**TOWN OF BAY HARBOR ISLANDS
MORRIS N. BROAD COMMUNITY CENTER
1175 95TH STREET
BAY HARBOR ISLANDS, FL 33154**

DEVELOPMENT & REVIEW COMMITTEE MEETING

**TOWN OF BAY HARBOR ISLANDS
COMMUNITY DEVELOPMENT
MEMORANDUM**

Subject: Site Development Plan Application
9761 West Bay Harbor Drive– 6 DU Townhouse Complex
Bay Harbor Luxury Townhomes
Bay Harbor Islands Acct. No. SPR2024-000021
MMPA Acct. No. 01-0702-1196

LANDSCAPE PLAN

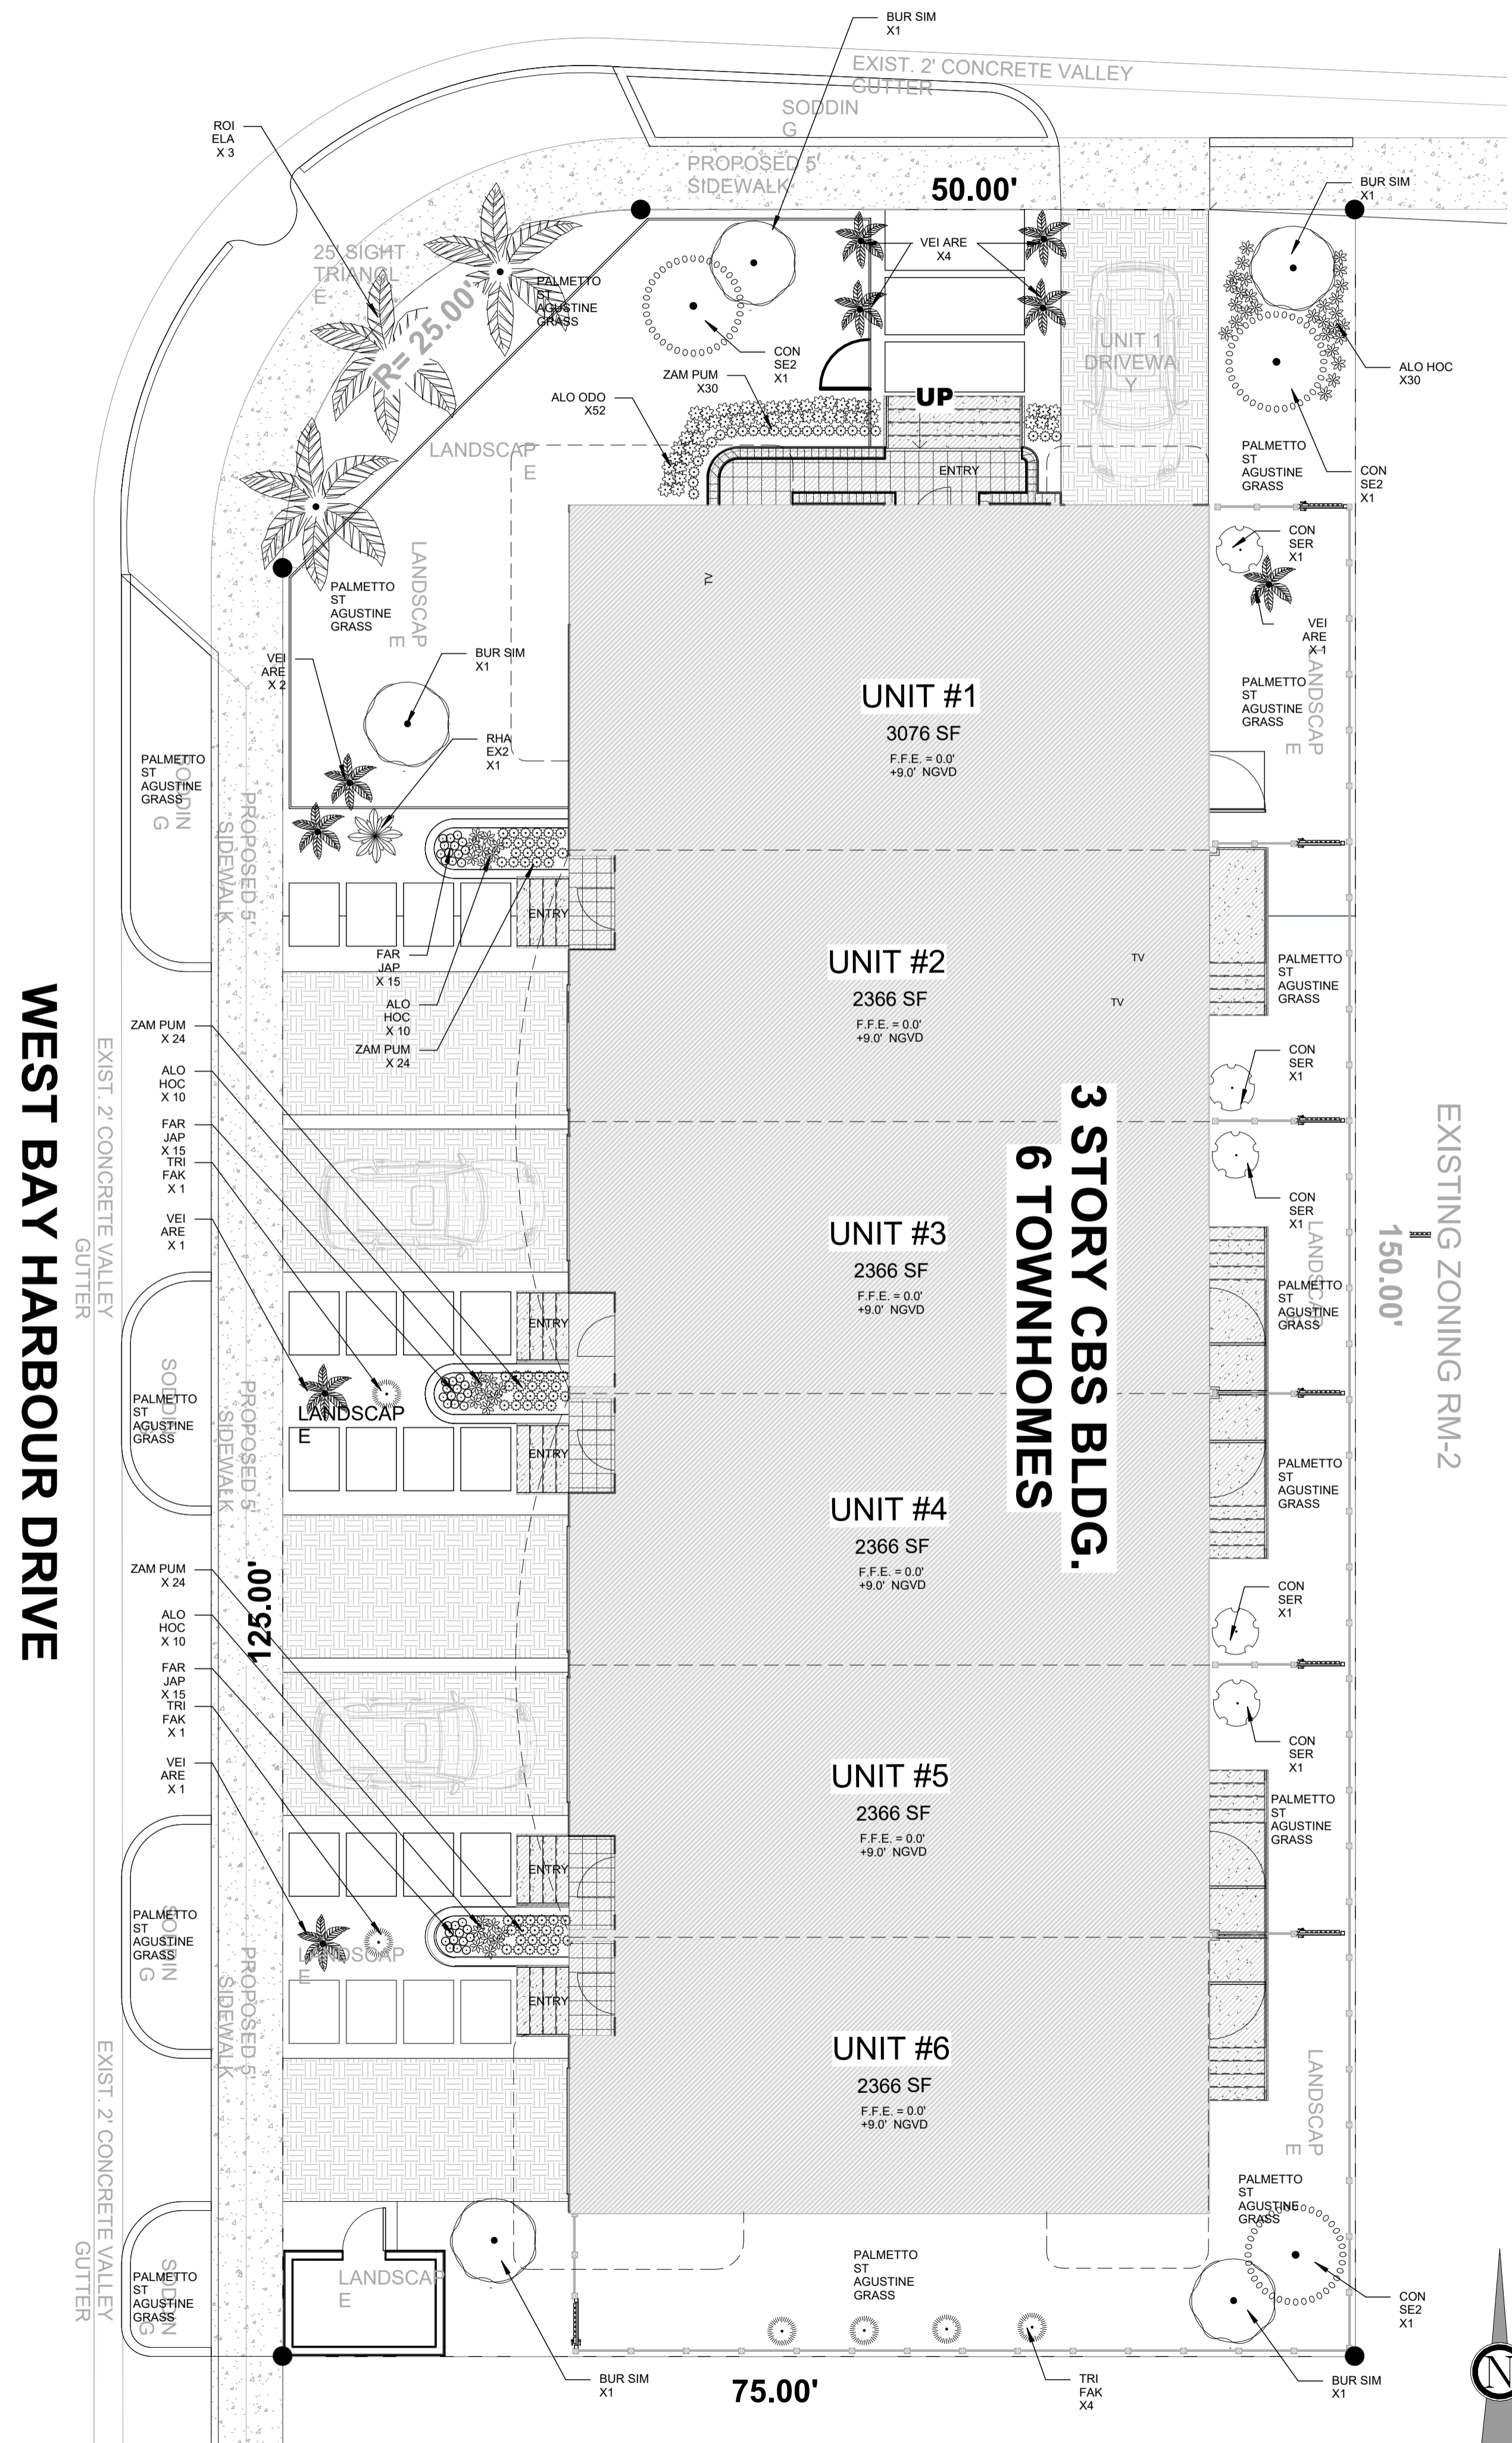
- 8) The Landscape Plan must be signed and sealed by a registered Florida Landscape Architect. Additionally, there are numerous items that do not meet the Town Code standards in Sec. 24-16. Use the attached template and provide it on the landscape plans.

- 16) Landscape plan sheet LSCPP-101 has the following comment:
 - a. The Landscape Plan needs to be revised to accurately reflect the Town's Supplemental Landscape Code requirements (Sec. 24-16) (% of native species, % of drought tolerant species, % of palms allowed, etc. in addition to the Miami-Dade County min. requirements.

- b. The plan does not provide the required street trees per Miami-Dade Ch. 18B. West Bay Harbor Drive requires Paradise Palm and 98th Street requires Gumbo Limbo trees. The street tree shall be a min. 15' in overall height with at least six feet of clear wood before branching, a min. caliper of two and one-half inches and shall be planted at to meet the Miami- Dade County at to meet the Miami- Dade County min. criteria of 35 feet on average separation but not shall exceed 40' on-center.

- c. Cannot plant Cuban Palms in the right of way of West Bay Harbor Drive and 98th Street.
